SERVICE LETTER #35

SUBJECT: Alignment of Vee Belt Sheaves

ROTORCRAFT AFFECTED: All R22 Helicopters

Figure 1
View Looking Forward

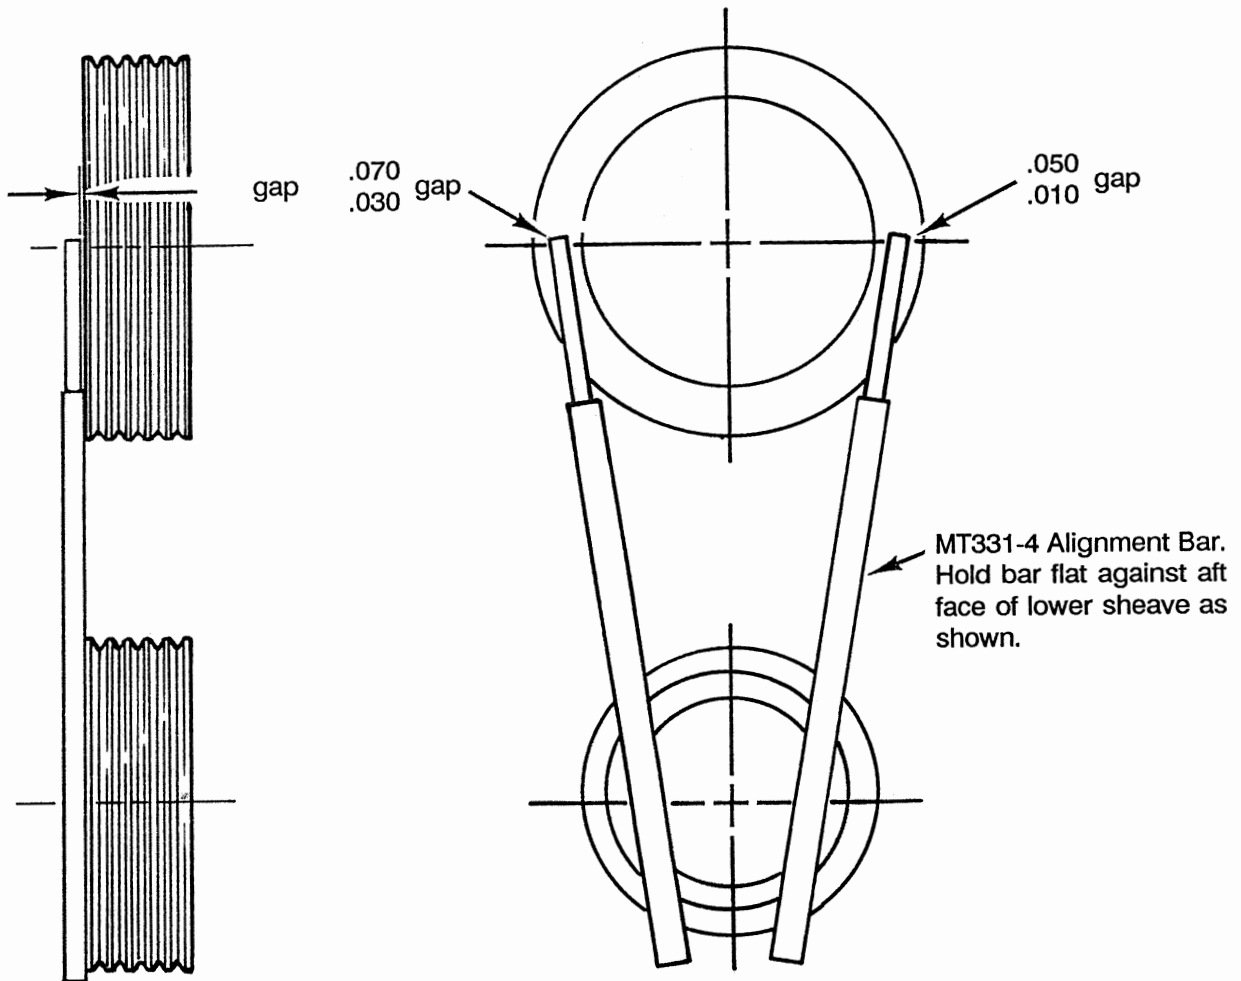
- a) Fully engage clutch actuator.
- b) Check sheave alignment on left and right sides per Figure 1 on reverse side.
- c) The clutch lateral centering strut may be adjusted to meet the requirements shown in Figure 1, but the following clearances must be maintained:
 - 1) Minimum .030 between clutch actuator motor and steel tube frame.
 - 2) Minimum .25 between V-belts and right side frame guard tube.

- a) Check engine ring gear to frame limits per Section 6.130 of the R22 Maintenance Manual.
- b) Fully engage clutch actuator.
- c) Check sheave alignment on left and right sides per Figure 1 on reverse side.
- d) If the measured gaps are not in tolerance, the upper sheave must be shimmed by adding or removing AN 960-516L washers at the forward flex plate, or by shimming the engine forward or aft per Section 6.130 of the R22 Maintenance Manual. Note: A maximum of one AN960-516L washer may be installed between the flex plate and either or both yokes. When a yoke is shimmed, both arms must have a washer.
- e) If the above shimming is not sufficient, a longer or shorter A907 yoke must be installed.
- f) Whenever the upper sheave is shimmed, the intermediate flex plate shims must be checked per Section 7.330 of the R22 Maintenance Manual.
